Re: Aurora Energy Ltd: Designation at Wakari Road

Form 18

Notice of requirement by Minister, local authority, or requiring authority for designation or alteration of designation

LAYOUT - SIDE VIEW

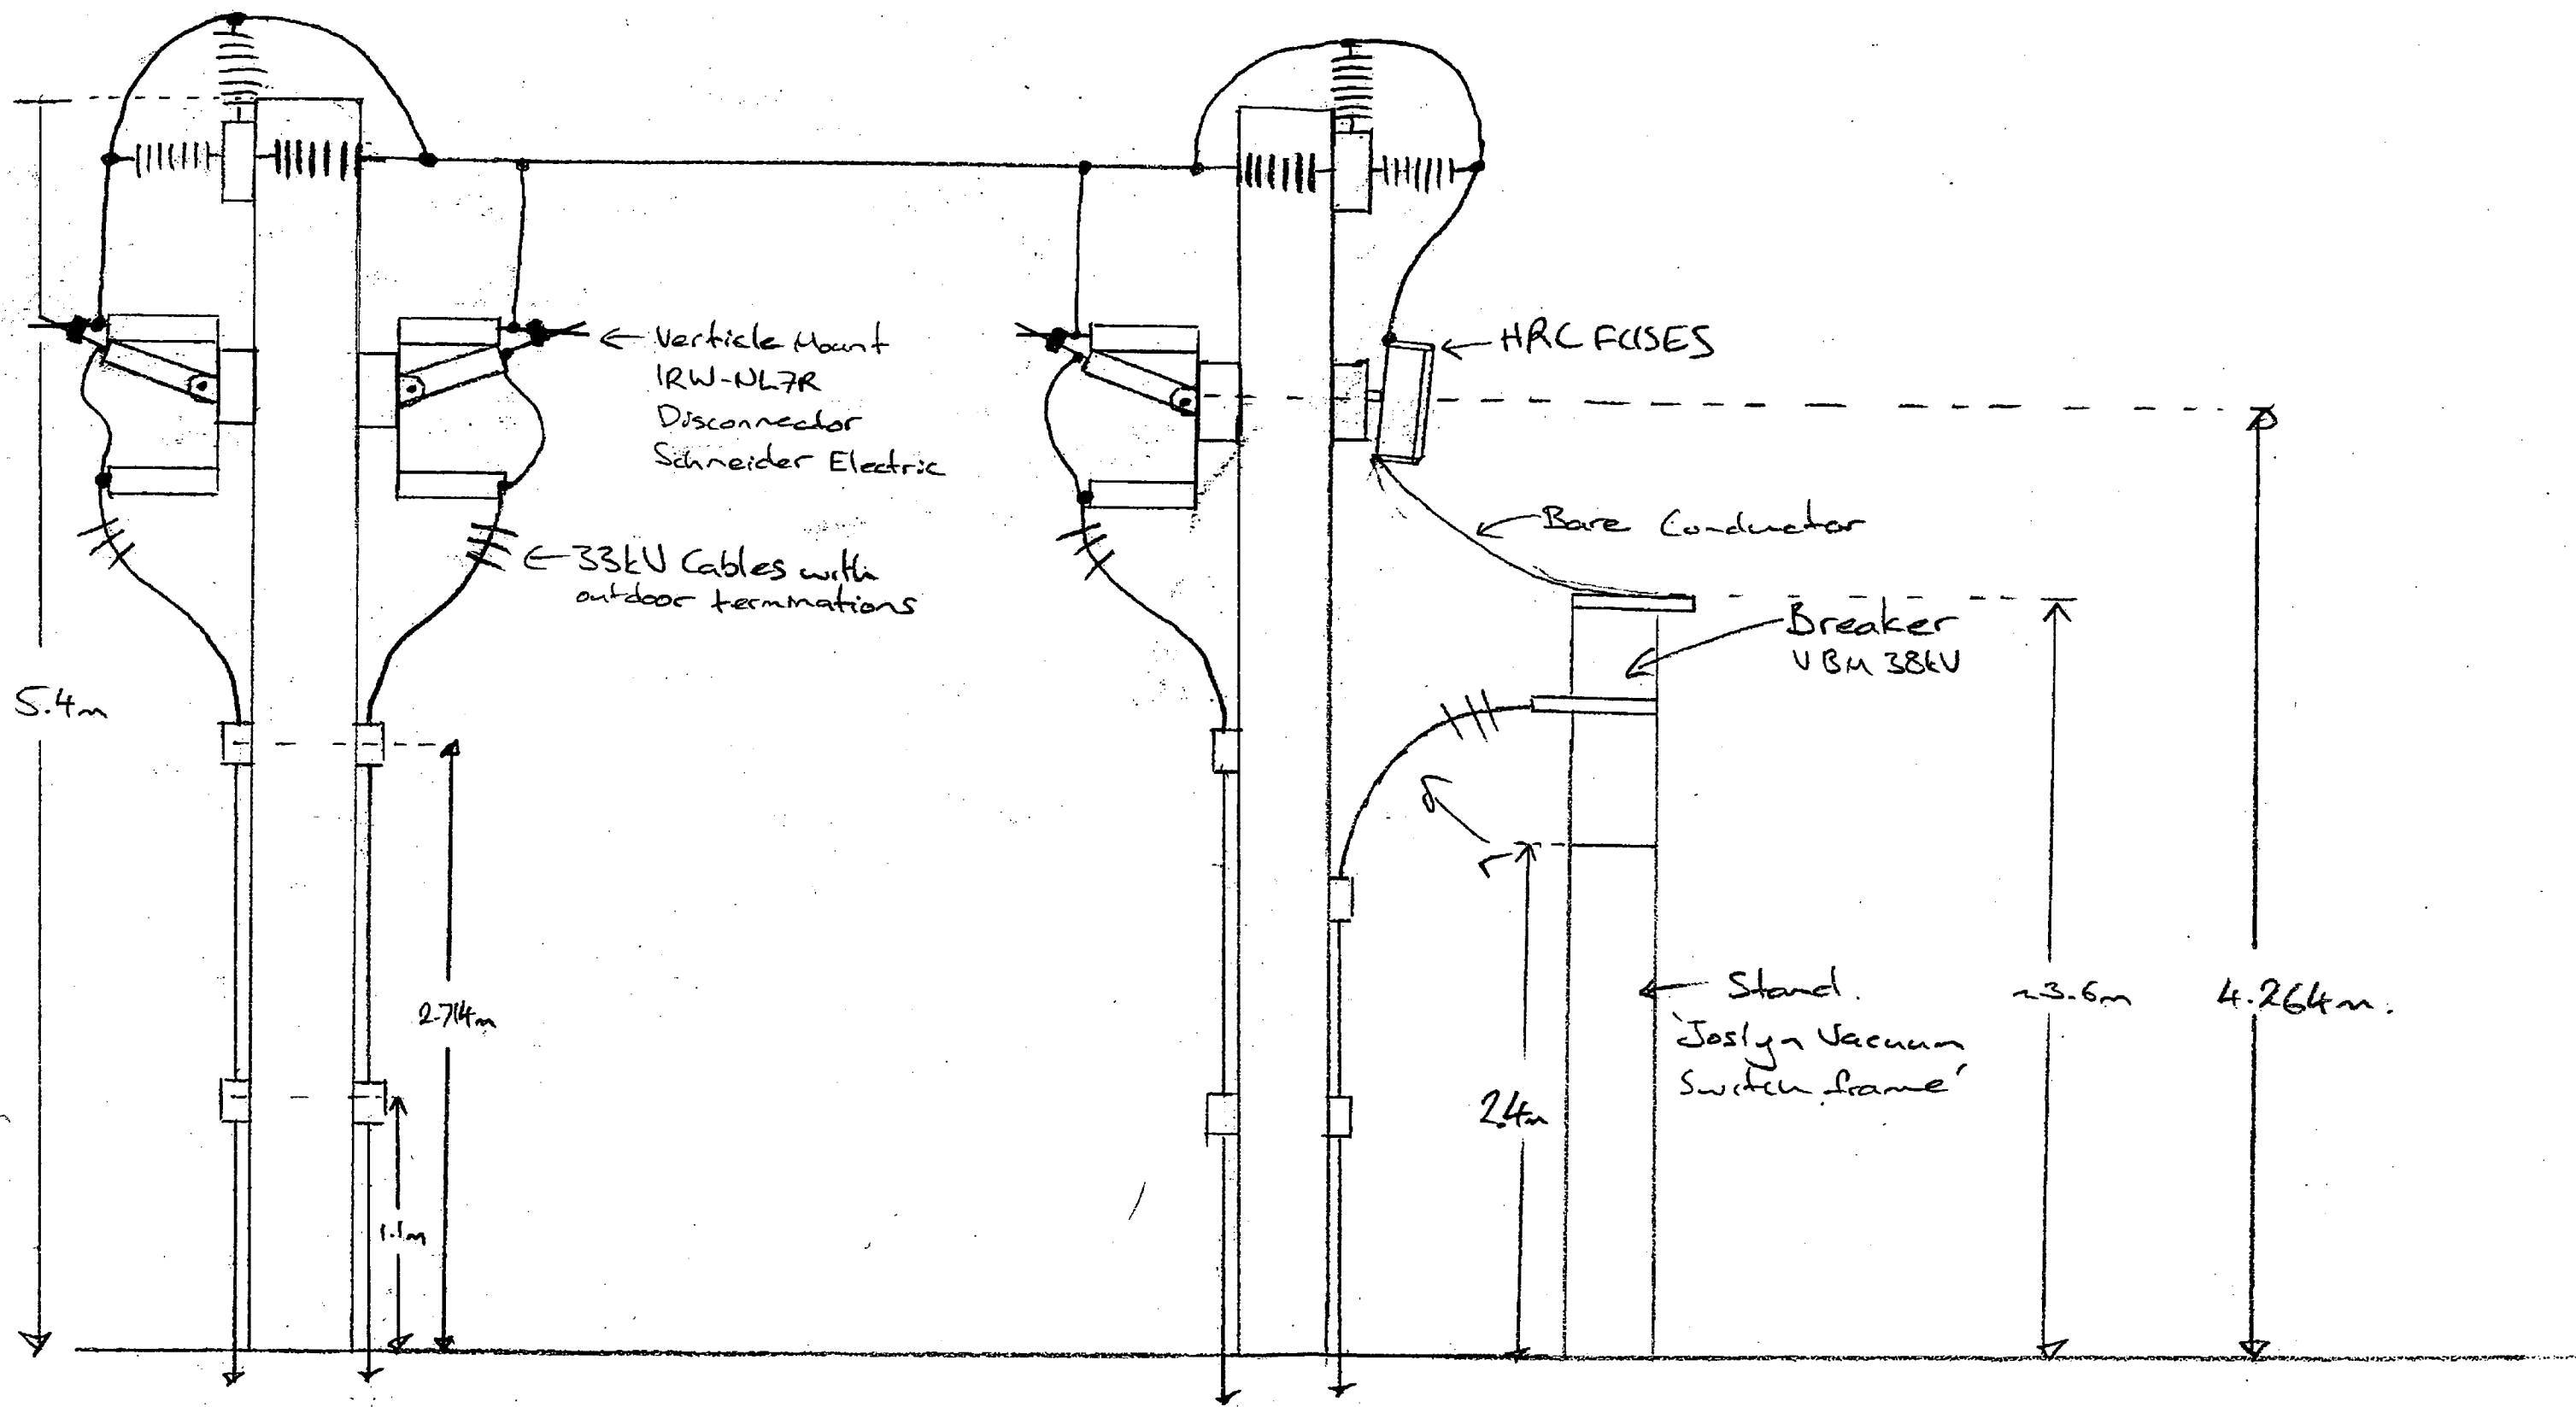
1. Could you tell me who your contact has been at CARS while consulting on this matter? We will need CARS' written approval for the works, as landowner, in order to be able to discount any effects on them.
2. Does the aerial photo entitled 'Halfway Bush GXP' show the footprints of all the proposed structures?
3. The aerial photo shows the two Ripple Injector Units as being 11950 x 2340 in dimension. I assume this means that the shipping containers the units are to be housed in are to be 11950mm long by 2340mm wide - is this correct?
4. What will the height of the shipping containers be? - this will be an important factor in determining their visual impact.
5. Could you confirm that the two '33kV CB & isolators' shown on the aerial photo are both to be of the dimensions shown in the diagram entitled 'Layout - Side View'? If not, please could you tell me their likely maximum height?

Yes, the aerial photograph entitled "Halfway Bush GXP" shows the location of the new works
 Yes, the dimensions of the containers are approximately 12mx2.5mx2.5m with the ripple control gear inside
 Yes, the freestanding switch gear is as shown on the sketch entitled " layout- Side View" and yes they look similar to the existing switch gear on the site

5 yes the two 33kV CB and isolators are both as shown on the side view and they both will present a view similar to the existing plant on the site
